City of Oxford
Community Development Department
STAFF REPORT
Board of Zoning Appeals

Case # BZA-2015-09

Date – May 20, 2015

BZA-2015-09 102 S. Locust Street El Burrito Loco variance to Section 1143.12(c)(2)A front yard setback **Scott Webb, Applicant/Agent**

SITE PLAN

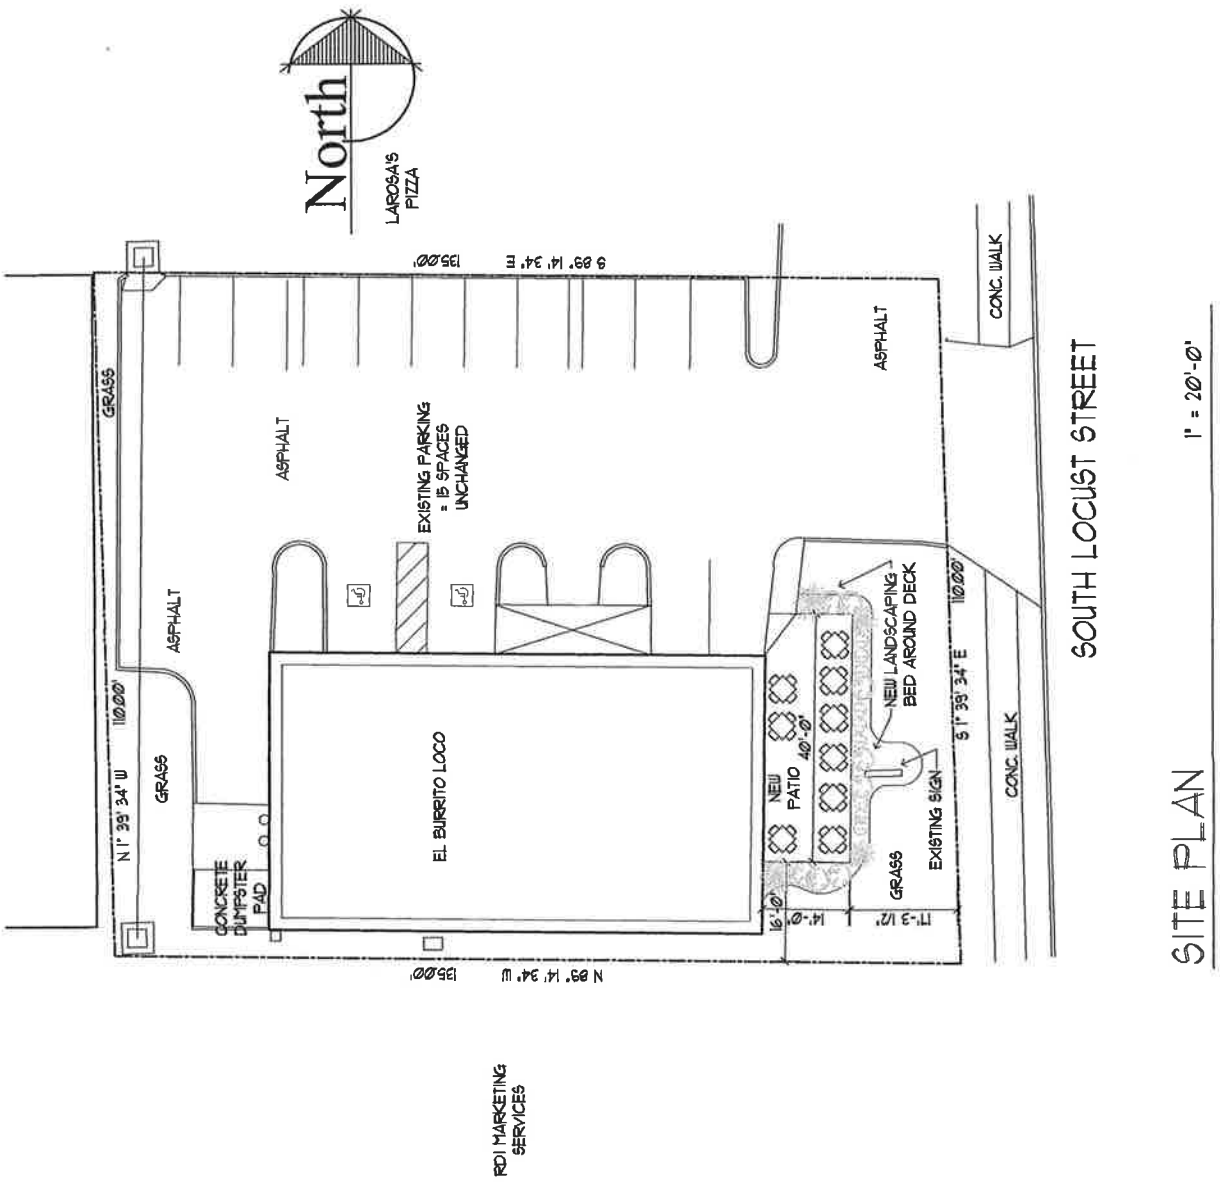
- The proposed outdoor patio/deck area for the restaurant encroaches into the front yard setback and is approximately 16 feet from the property line, since the right of way line is not completely parallel with the outline of the proposed deck. Therefore, the nearest setback would be 16 feet from the property line.

The El Burrito Loco building and parking is currently setback 30' from the property line. The parking spaces at 110 S. Locust are 5.5' from the front property line, 114 S. Locust is 23' and Walgreens parking is a 0' setback. Walgreens (2004), El Burrito (2003), 110 S. Locust (2009) were granted variances for their setback encroachments and there is no record of a variance being granted for 114 S. Locust or the LaRosa's property. The LaRosa's property may have been approved through the PUD process.

Parking should be discussed. While this proposed outdoor area will only be used seasonally, additional parking should be provided or the existing shared parking easement established in 2003 should be expanded to accommodate additional spaces. In 2003 the property was granted a waiver to the parking, only requiring 15 on-site spaces and 11 shared spaces to the north. The Applicant should provide documentation that they have ample parking available to them to service the additional outdoor eating space. The current code requires additional 4 spaces to accommodate the expansion. The submitted site plan did not indicate how the additional spaces could be accommodated on the site. Given the changes to the parking and site access of the Oxford Zoning Code, the site could conceivably accommodate more off-street parking, but it is unclear how many at this point since the site plan provided was not based on the new changes. This could be an issue for the Board to consider in the future for the same business, should the current request be approved and a building plan get drawn and it is determined that the number of parking spaces are not sufficient for the expanded business. Therefore, the pending request may not be the only variance this application would need to obtain.

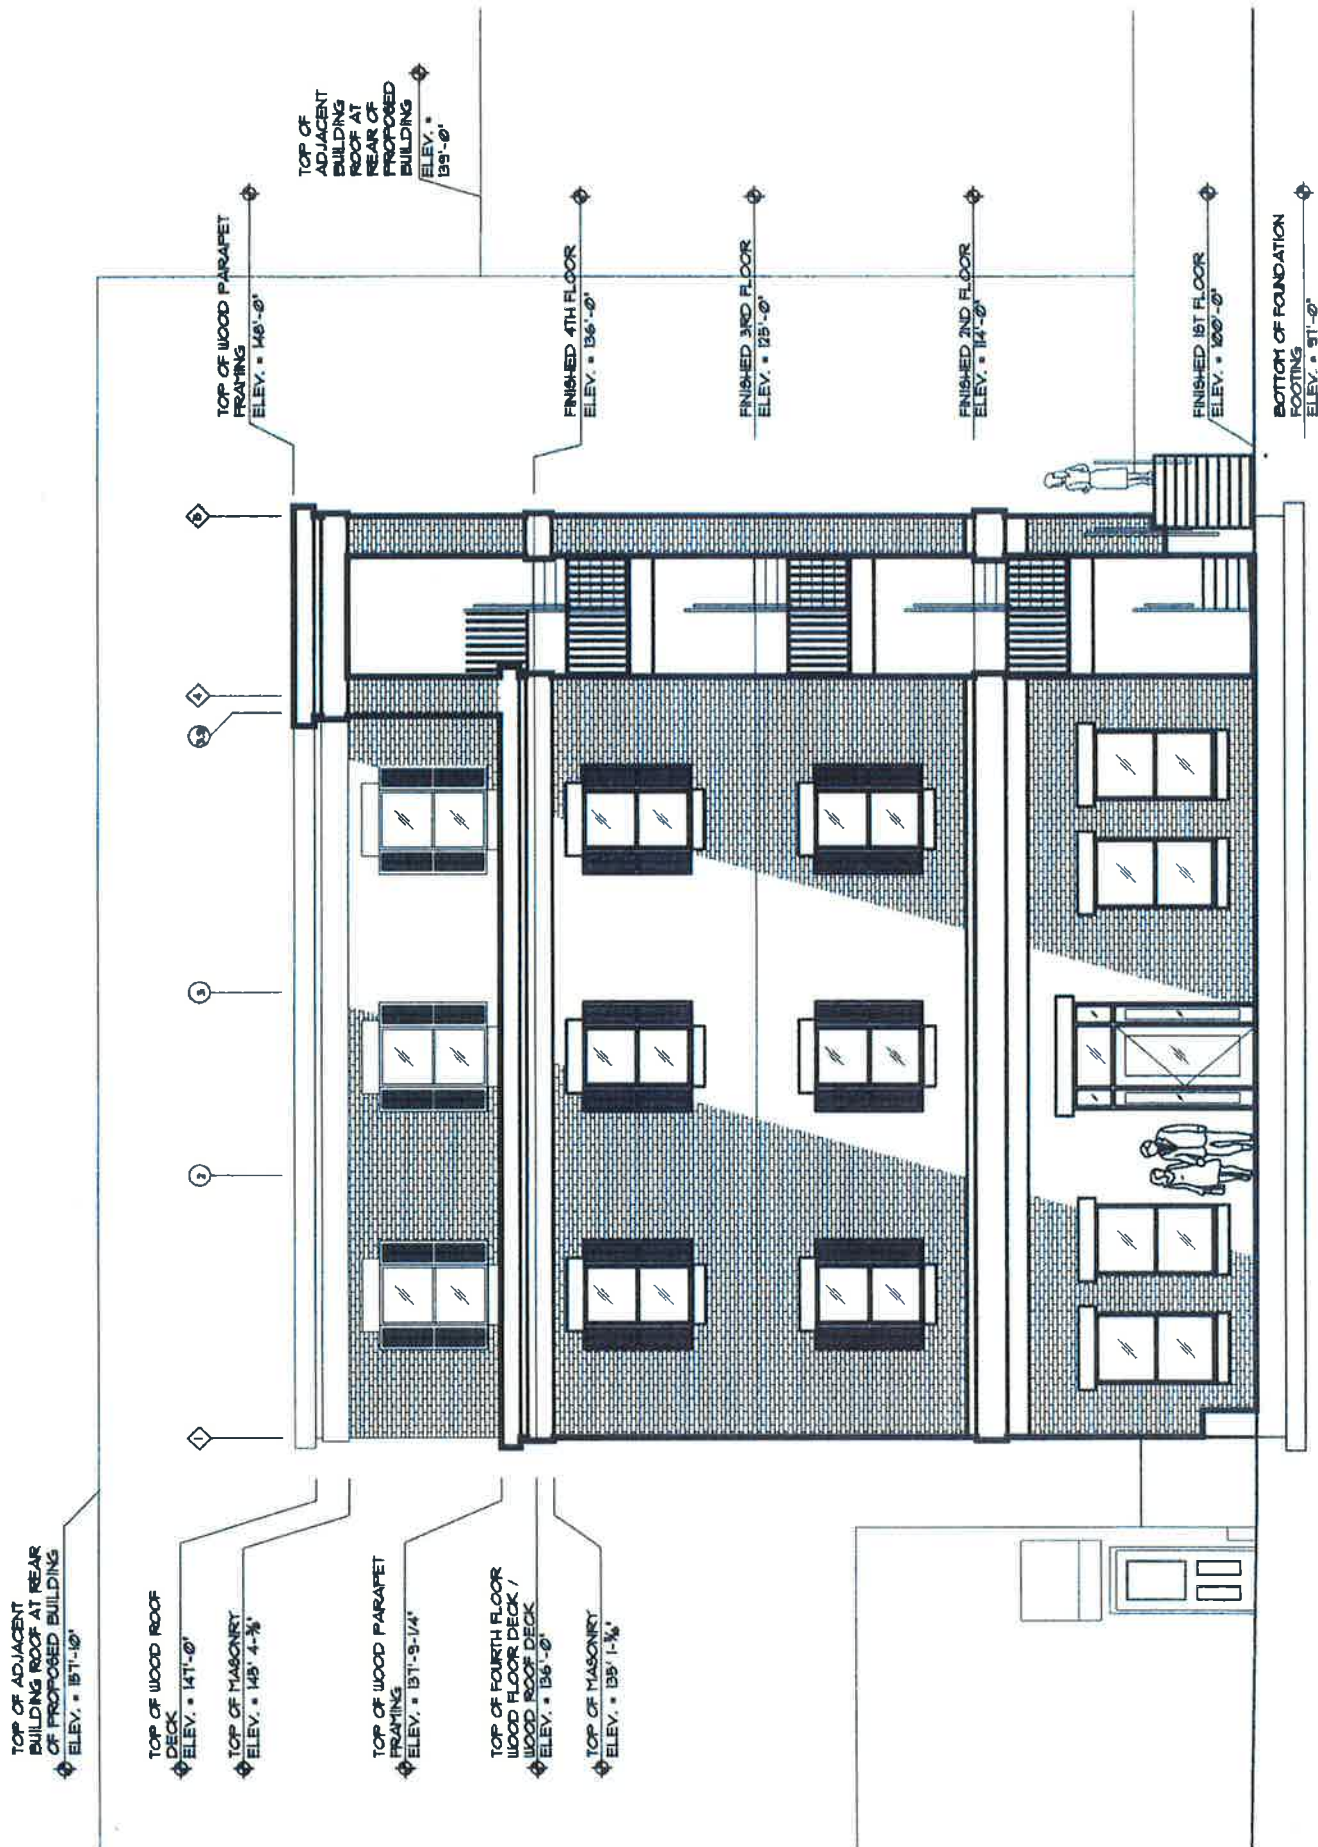
1. Total Building Floor Area Ratio and Total Residential Floor Area Ratio are both over the allowable limits. The stairs and halls are required to be included in the calculation as they are within the exterior walls of the definition of Gross Floor Area. A plan revision or BZA variance application will be required. [Section 1143.10(c)(3)B.]

3. Screening is required for the waste and recycling storage area as it is in public view. [Section 1141.04(j)(3)D]
4. The grade change between the waste storage area and the street is not feasible for moving totes up and down stairs. A different location without grade changes is suggested.

6. The plans include the front patio as a portion of square footage required to meet the commercial area Gross FAR. Therefore the plans shall clearly label the patio for commercial use only.

Per the Oxford Zoning Code the removal of the stairwell and hall exterior walls will resolve the issue. The revised stairwells and halls will be composed of structural masonry pilasters and metal architectural railings. The stairwells will essentially be an open design with no exterior walls. Per the definition of gross floor area (section 1159.07) the revised stairwells and halls will not be part of the gross floor area. In addition, it shall not be included in the residential space, which includes "outdoor patios, decks, and balconies..." (section 1143.10 B.1.b. i.). This is due to the fact that the exterior halls and stairwells are not a "patio, deck, or balcony". These revisions will ensure that the new building will meet the total building floor area and total residential area ratios. I have included the key provisions of the Oxford Zoning Code for review.
